Model: Martini-C1

No.: RB064002

Subject: Jogger Fence Adjustment		Prepared by: Y.Urushihara	
From: 1st Tech. Support Sec. Service Support Dept.			
Classification:	<input type="checkbox"/> Troubleshooting <input type="checkbox"/> Mechanical <input type="checkbox"/> Paper path <input type="checkbox"/> Other ()	<input type="checkbox"/> Part information <input type="checkbox"/> Electrical <input type="checkbox"/> Transmit/receive	<input type="checkbox"/> Action required <input checked="" type="checkbox"/> Service manual revision <input type="checkbox"/> Retrofit information

Model: Martini-C1		Date: 4-Oct-02	No.: RB064005
Subject: Finisher screw detaches from slide rail bracket		Prepared by: K. Miura	
From: Technical Services sec. Service Planning Dept.			
Classification:	<input checked="" type="checkbox"/> Troubleshooting <input type="checkbox"/> Mechanical <input type="checkbox"/> Paper path <input type="checkbox"/> Other ()	<input type="checkbox"/> Part information <input type="checkbox"/> Electrical <input type="checkbox"/> Transmit/receive	<input type="checkbox"/> Action required <input type="checkbox"/> Service manual revision <input type="checkbox"/> Retrofit information

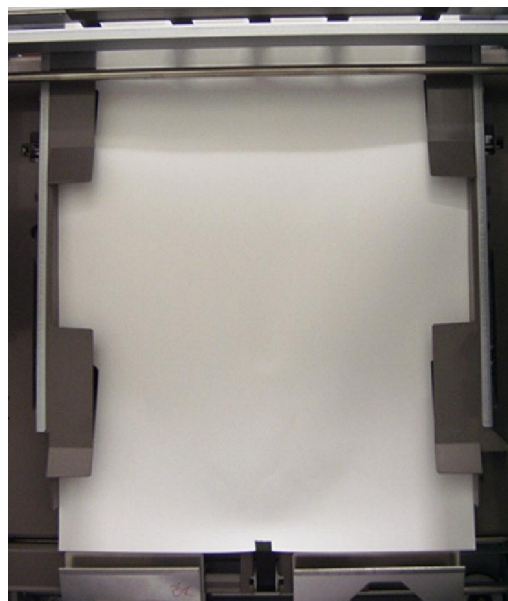
1. Move the belt hook down to the position shown in the photograph to the right by moving the stack feed out belt on the rear side of the unit by hand.

Important: Do not move the belt by the hook itself. Also, be sure to move the belt in the correct direction, shown by the arrow in the photograph below.

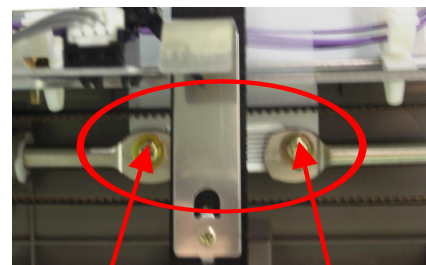
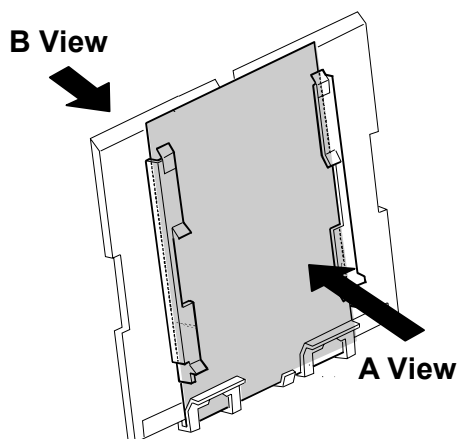
8. Adjust the **rear** jogger shaft position until the top edge of the upper stay and upper edge of the board are parallel to one another.

Left edge height + Right edge height = **0.5mm or less.**

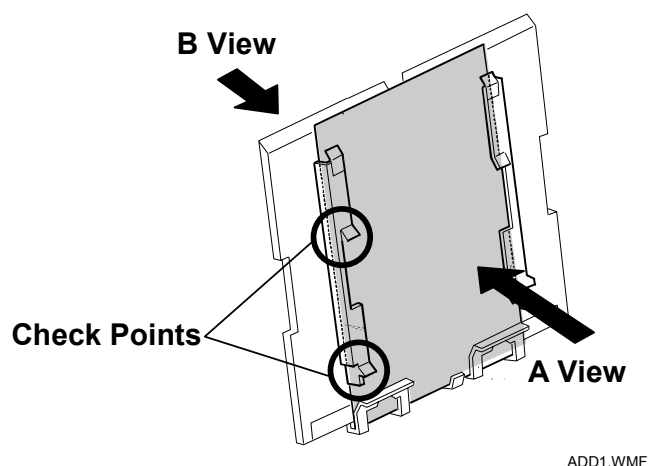
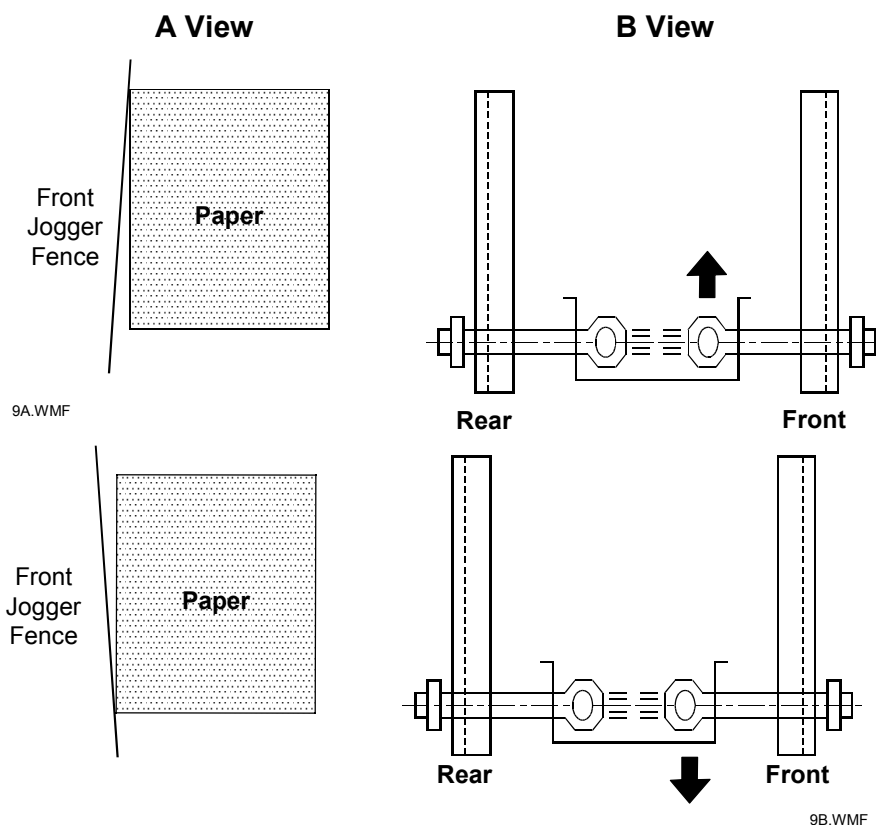
10. Bring the **front** jogger fence flush against the edge of the board, then adjust the front fence shaft until the board/fence gaps on both sides are:
Board/fence gap (top + bottom) = **0 - 0.5mm**.

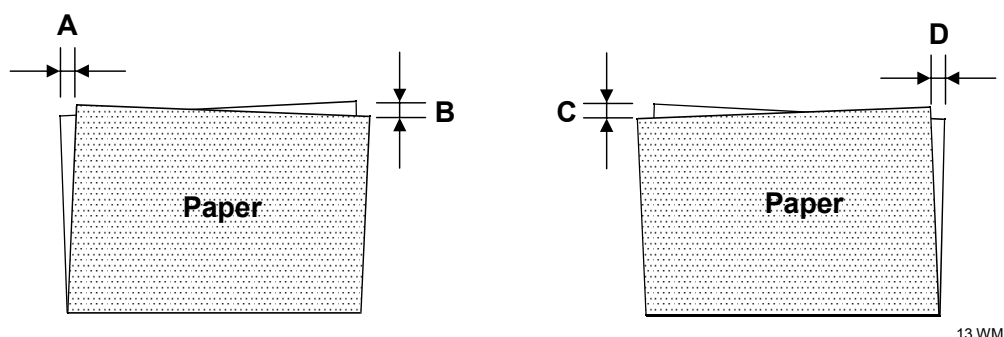
12. Print out 3 Booklet sets (2-3 sheets each) and check for folding skew.

All distances shown below (A, B, C, D): **2mm or less.**

13. If A, B, C or D is **over 2mm**, perform the following.

- Open the finisher front door, then insert a driver or other tool into the door switch to create the door-closed condition. Also, make sure to push in the stapler unit.
- Print out 3 Booklet sets (2-3 sheets each) using the exposure glass (not the DF).
- Once the paper is fed into the stapler unit and the machine stops operation, pull out the stapler unit.
- Press the “#” key on the operation panel, and then pull out the driver from the door switch as soon as the jogger fences close in to the paper edges from the standby position (10mm outside the paper width).
- Check to see that the paper/fence gaps on both sides are:
Paper/fence gap (top + bottom) = **0 - 0.5mm.**
If the fences are positioned too wide or too narrow, adjust the gap to 0 – 0.5mm for the given paper size using **SP6120.**

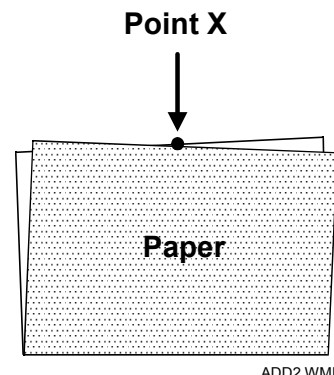
15. Adjust the folding position using **SP6902** until the two edges intersect in the middle (point X). This will minimize vertical folding skew, i.e. bring the leading/trailing edges of the sheets closer together.

14A.WMF

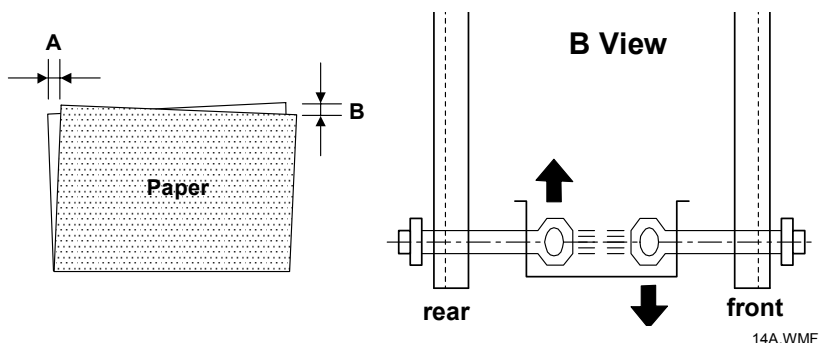
- 1) If A/B are over 2mm, **raise** the rear jogger fence shaft and re-secure the shaft in place. Then, loosen the screw for the front jogger fence shaft, **lower** the shaft to bring the front jogger fence flush against the paper, and re-secure the shaft in place.

14B.WMF

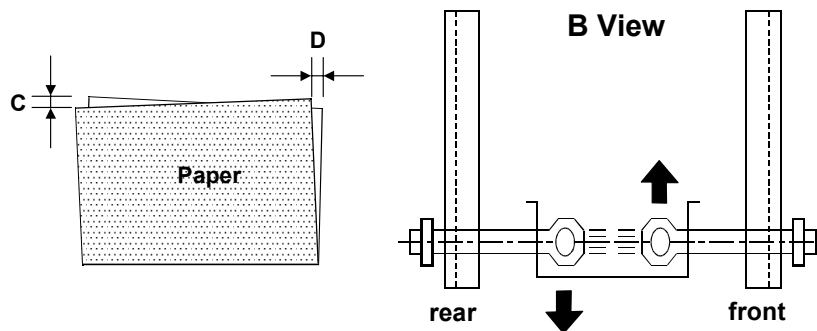
- 2) If C/D are over 2mm, **lower** the rear jogger fence shaft and re-secure the shaft in place. Then, loosen the screw for the front jogger fence shaft, **raise** the shaft to bring the front jogger fence flush against the paper, and re-secure the shaft in place.

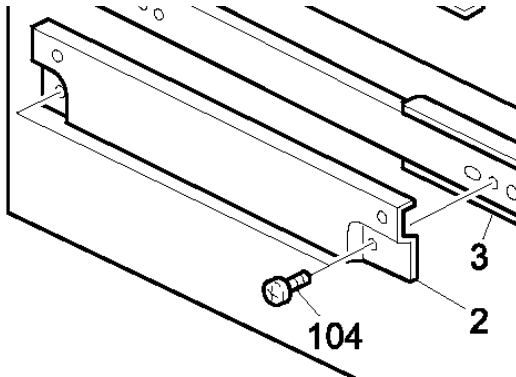
The screw shown below (Frame section 20, P/N #04533006B, pg. 45 #104) comes loose and detaches from the slide rail bracket.

Vibration during transport.

As a permanent solution, the screws have been equipped with spring-washers. As a temporary solution in the field, please perform the procedure below.

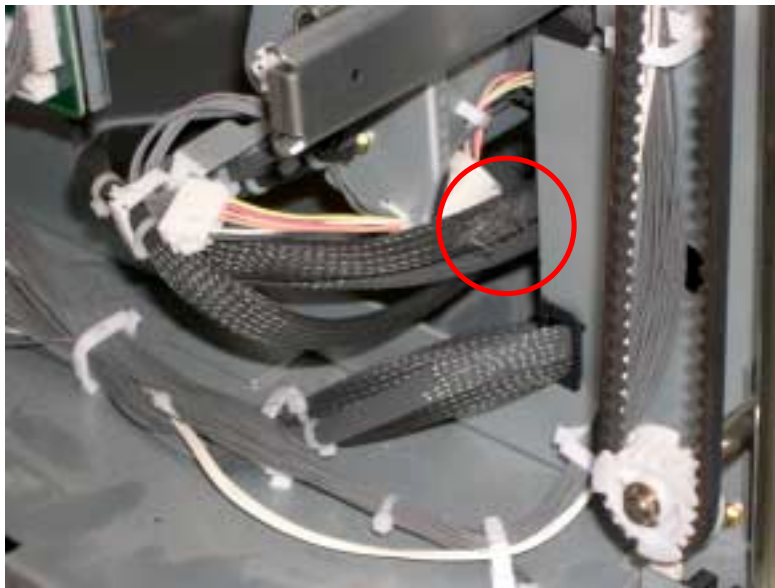
The outside of the stapler harness is damaged in the area shown in the photo. In some cases, a short circuit occurs in the damaged area.

The stapler harness rubs against the finisher rear plate when the stapler unit is pulled out or pushed in.

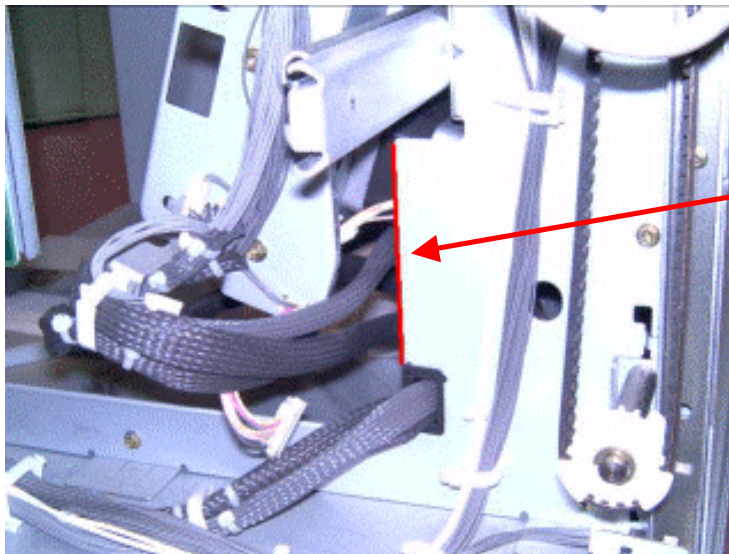
The shape of the rear plate has been changed so that it does not touch the stapler harness (the cut-in serial number is in the table below).

Attach a piece of insulating tape to the area of the rear plate shown in the photo (red mark).

Attach the tape here
